Neopixel Development PCB R3

PG 4/7/2021

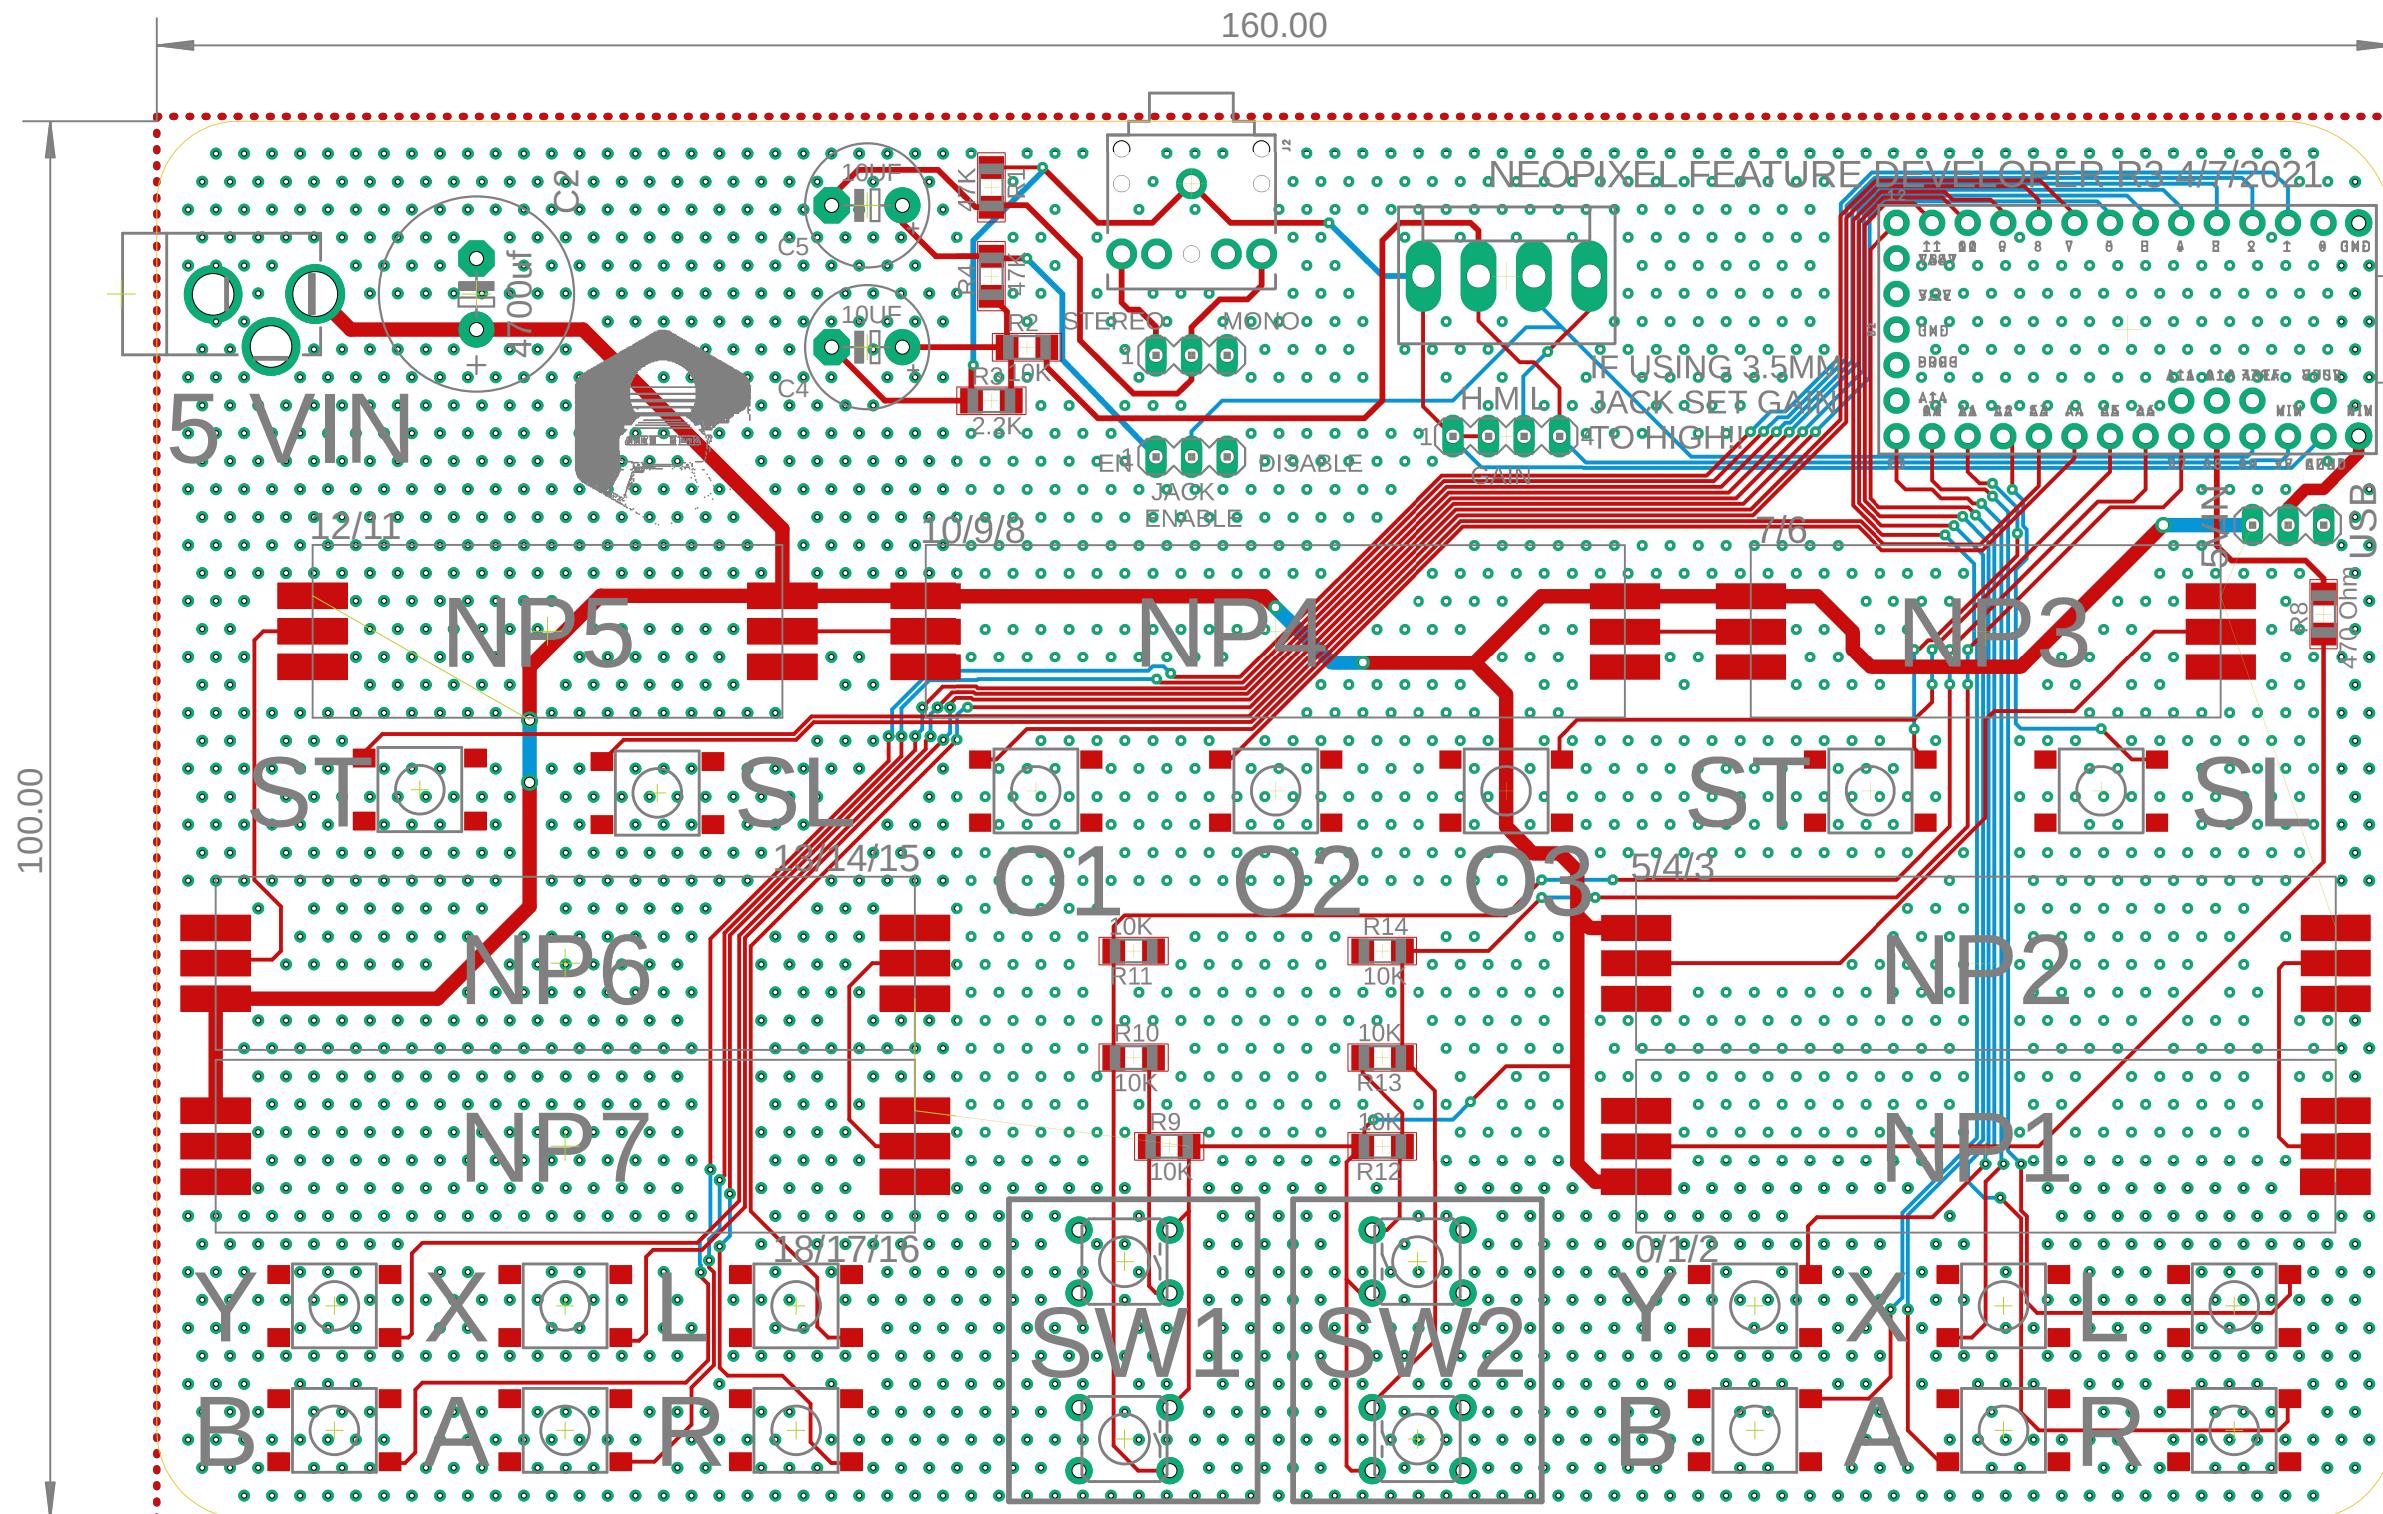
11-4-2020 - (R2) - R2 UPDATES:

- MOVED ALL CONTROLS UP ONE PIN ON TEENSY  
(D0 WOULD NOT REGISTER A ON P1).
  - REMOVED OPT4 AS IT IS NOT USED IN THE DESIGN.

4-7-2021 - (R3) - R3 UPDATES:

- MOVED GND PIN ON ALL INPUT BUTTONS 1/2P (ABCXYZ OPT1/2/3) - BUTTONS THAT ARE USED ON THE PCB BRIDGE HORIZONTALLY NOT VERTICALLY
  - UPDATED R9,R10,R12,R13 TO 10K (FORMERLY 1K) AS THE VOLTAGE NEEDED TO DROP BELOW 3.3V FOR TEENSY TO RECOGNIZE BUTTON PRESSES

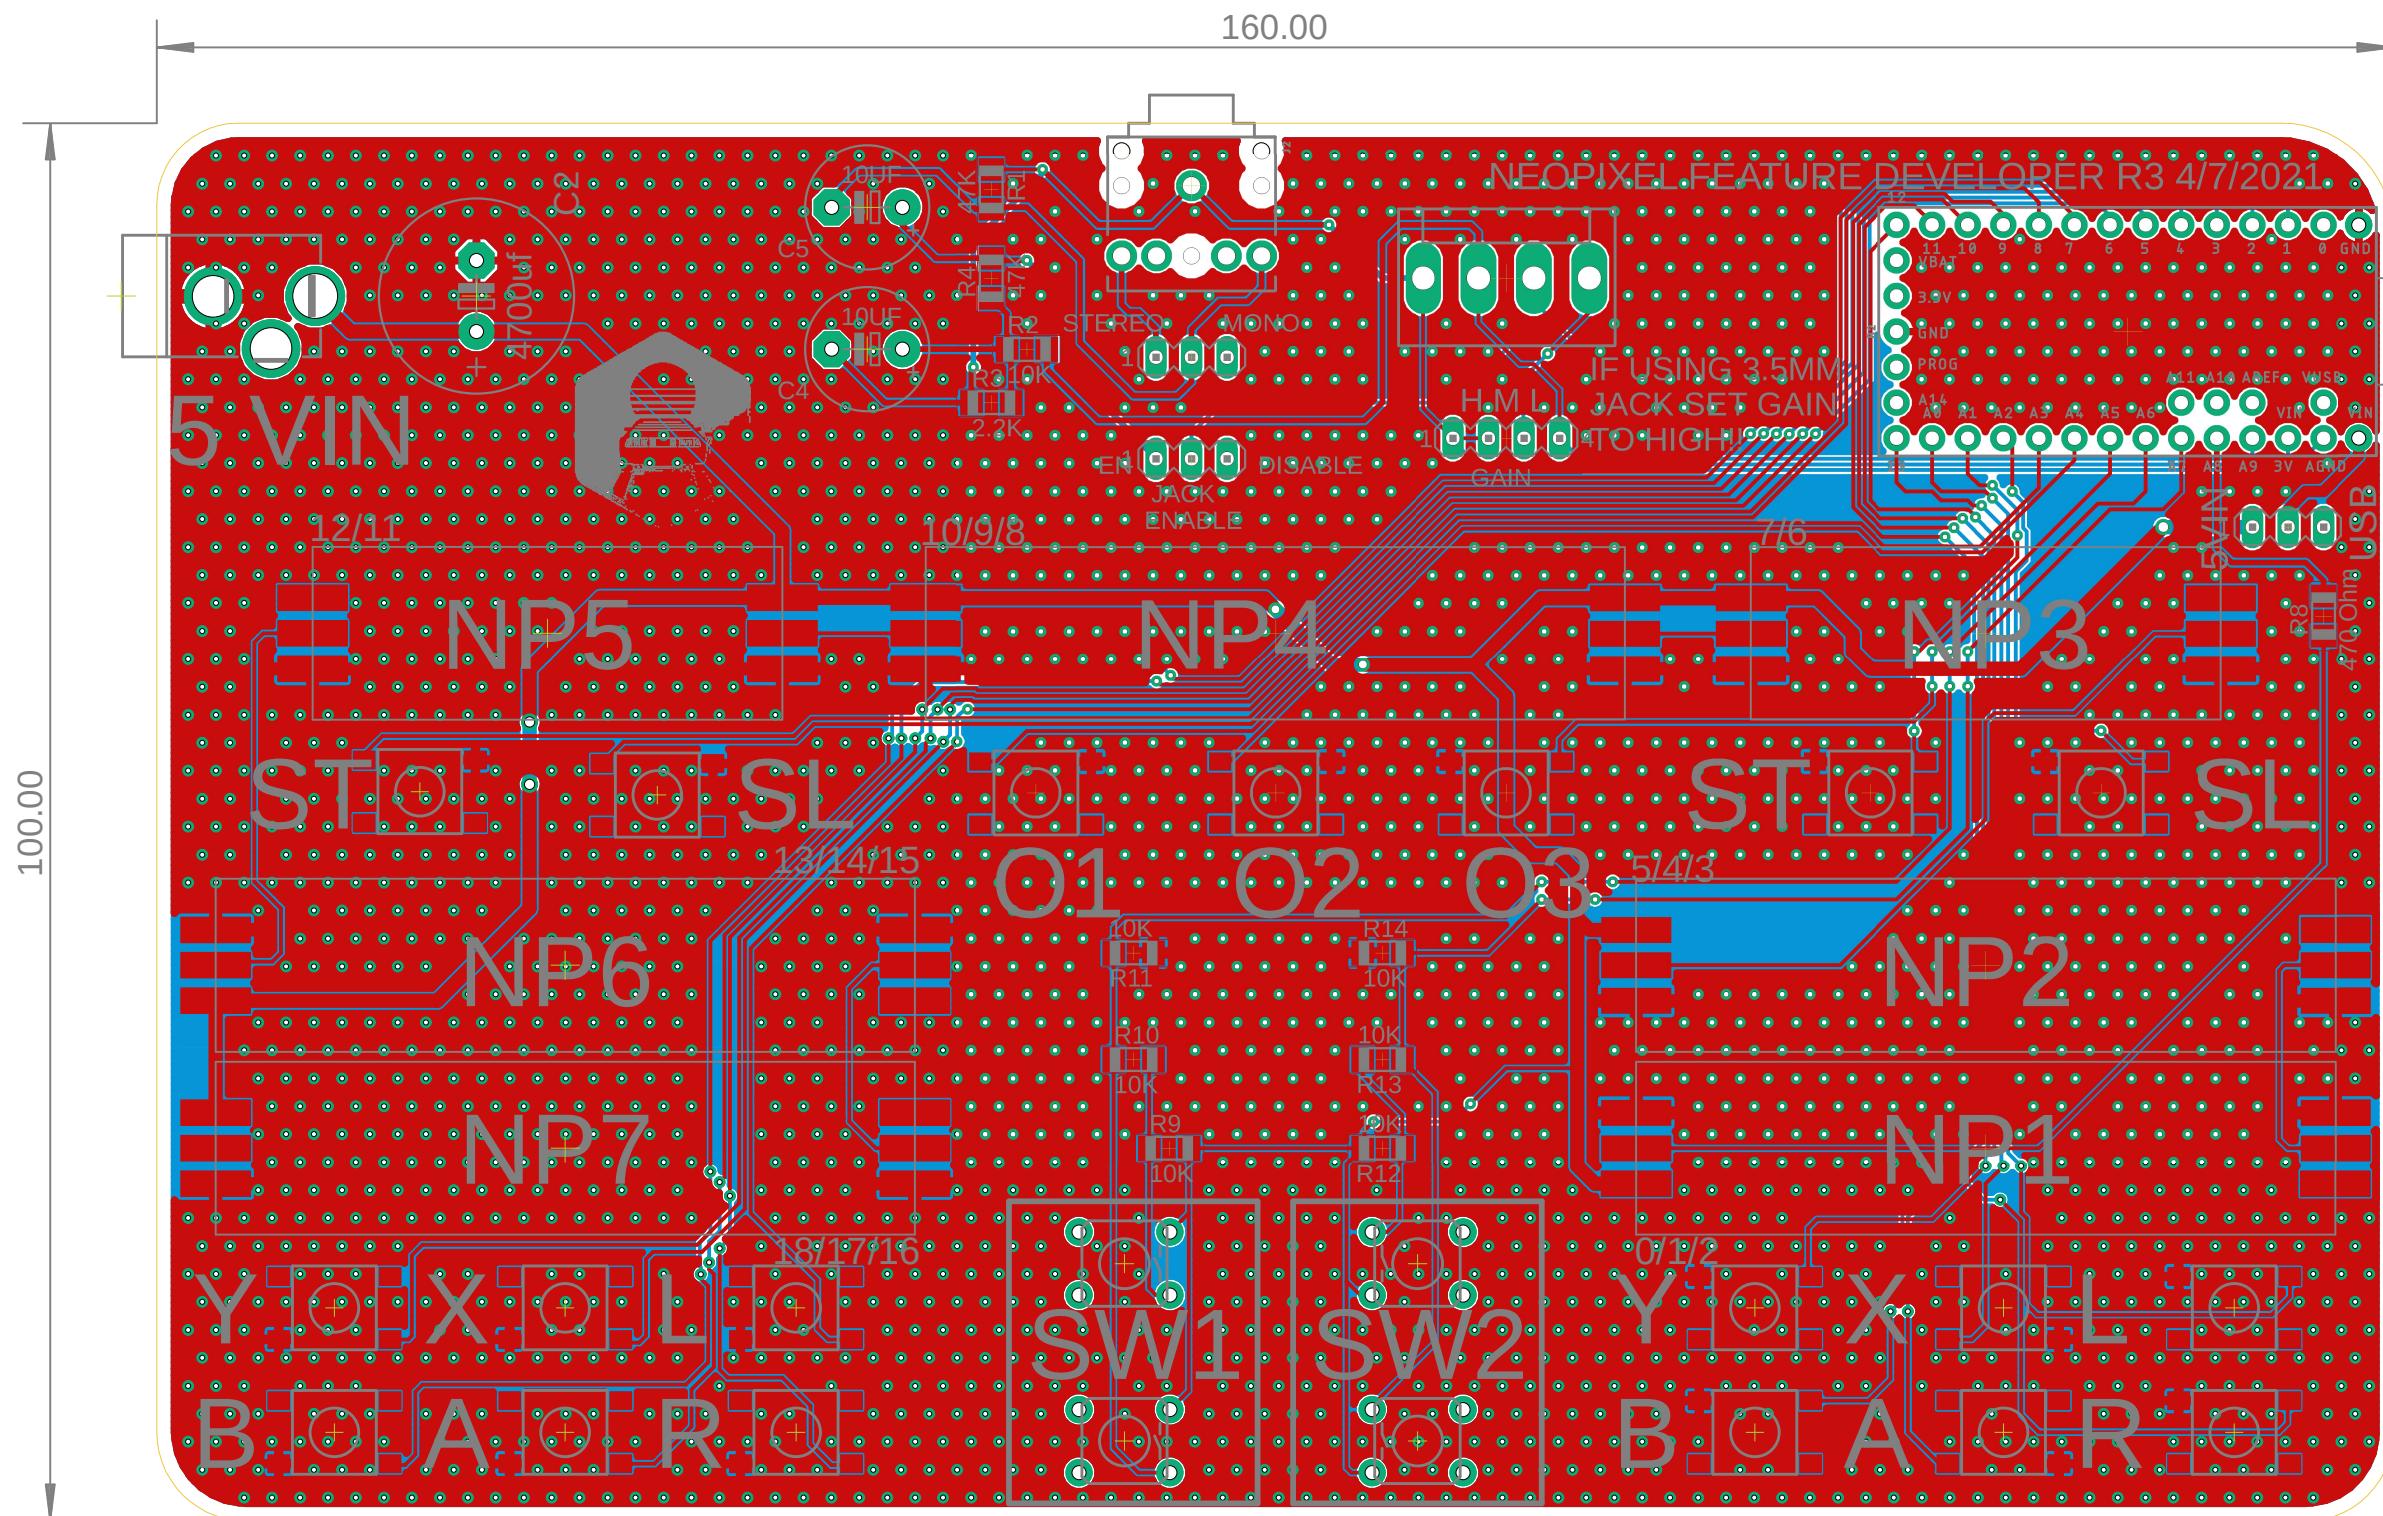
11-4-2020 - (R2) - R2 UPDATES:

1. MOVED ALL CONTROLS UP ONE PIN ON TEENSY  
(D0 WOULD NOT REGISTER A ON P1).
2. REMOVED OPT4 AS IT IS NOT USED IN THE DESIGN
3. ALL INPUT TRACES RERUN, STITCHING RERUN TO MATCH NEW TRACES
4. ADDED VIA STITCHING TO GND PLANE

4-7-2021 - (R3) - R3 UPDATES:

1. MOVED GND PIN ON ALL INPUT BUTTONS 1/2P (ABCXYZ OPT1/2/3) - BUTTONS THAT ARE USED ON THE PCB BRIDGE HORIZONTALLY NOT VERTICALLY
2. UPDATED R9,R10,R12,R13 TO 10K (FORMERLY 1K) AS THE VOLTAGE NEEDED TO DROP BELOW 3.3V FOR TEENSY TO RECOGNIZE BUTTON PRESSES

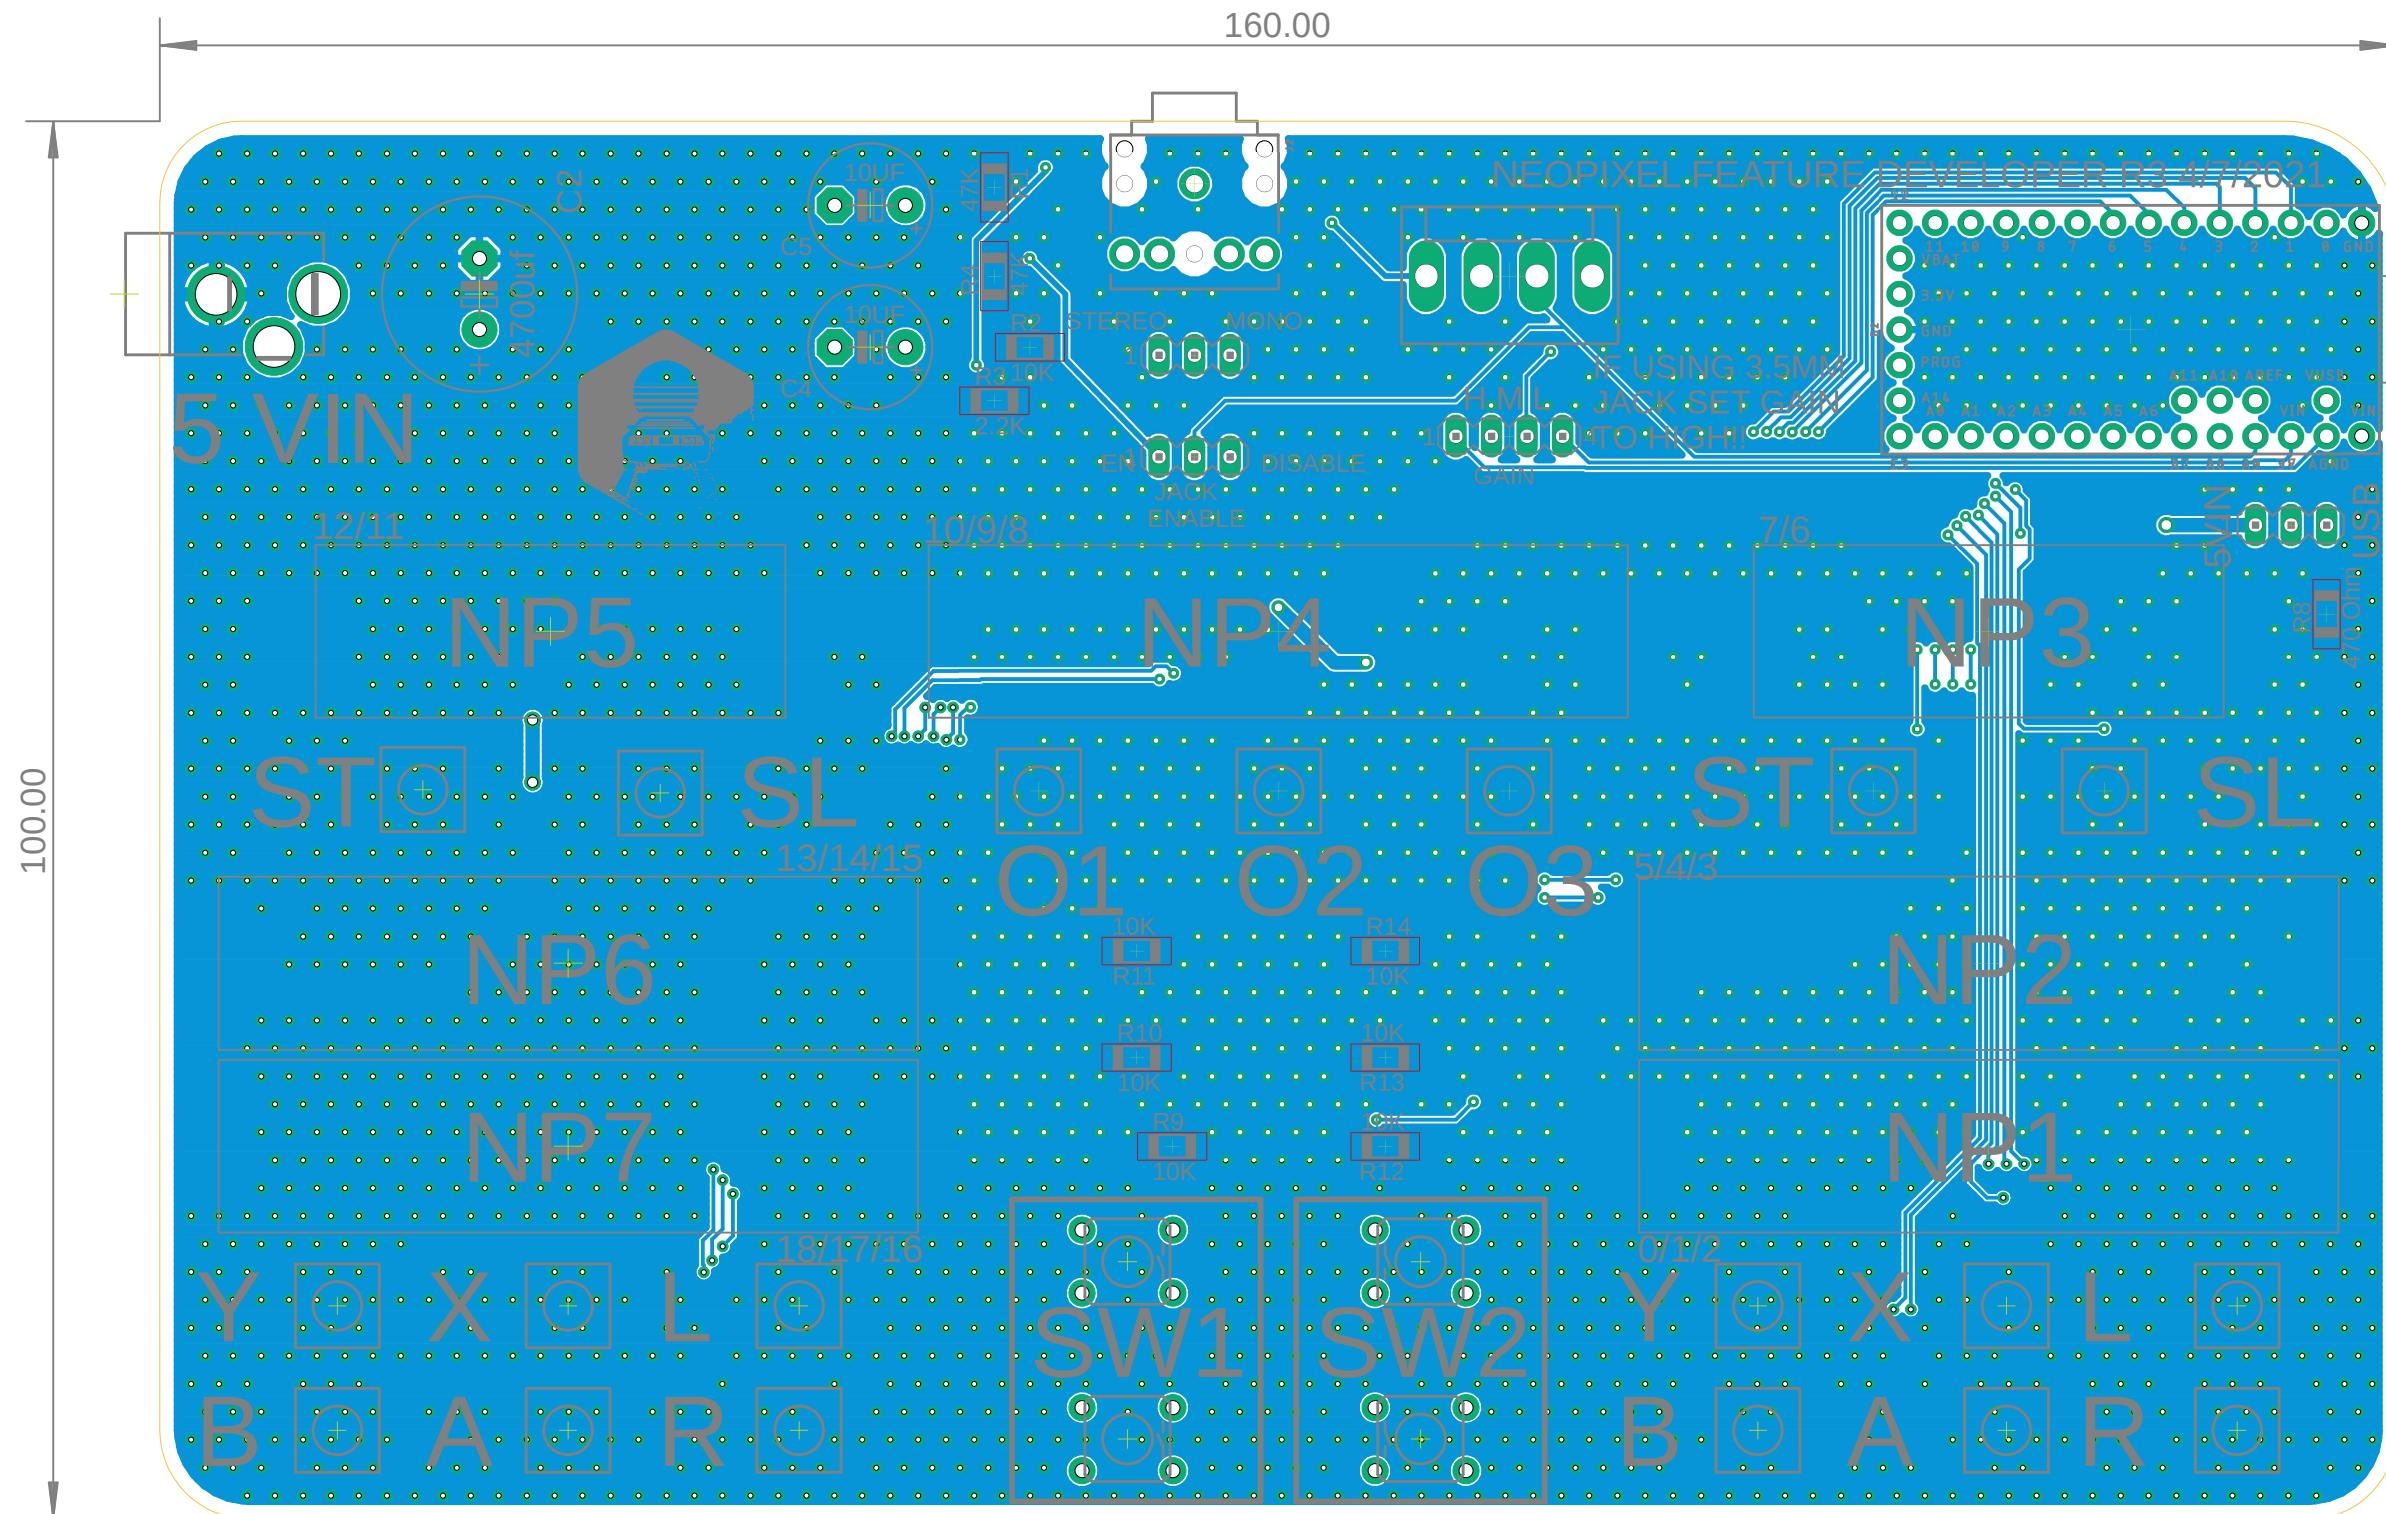
11-4-2020 - (R2) - R2 UPDATES:

1. MOVED ALL CONTROLS UP ONE PIN ON TEENSY  
(D0 WOULD NOT REGISTER A ON P1).
2. REMOVED OPT4 AS IT IS NOT USED IN THE DESIGN
3. ALL INPUT TRACES RERUN, STITCHING RERUN TO MATCH NEW TRACES
4. ADDED VIA STITCHING TO GND PLANE

4-7-2021 - (R3) - R3 UPDATES:

1. MOVED GND PIN ON ALL INPUT BUTTONS 1/2P (ABCXYZ OPT1/2/3) - BUTTONS THAT ARE USED ON THE PCB BRIDGE HORIZONTALLY NOT VERTICALLY
2. UPDATED R9,R10,R12,R13 TO 10K (FORMERLY 1K) AS THE VOLTAGE NEEDED TO DROP BELOW 3.3V FOR TEENSY TO RECOGNIZE BUTTON PRESSES
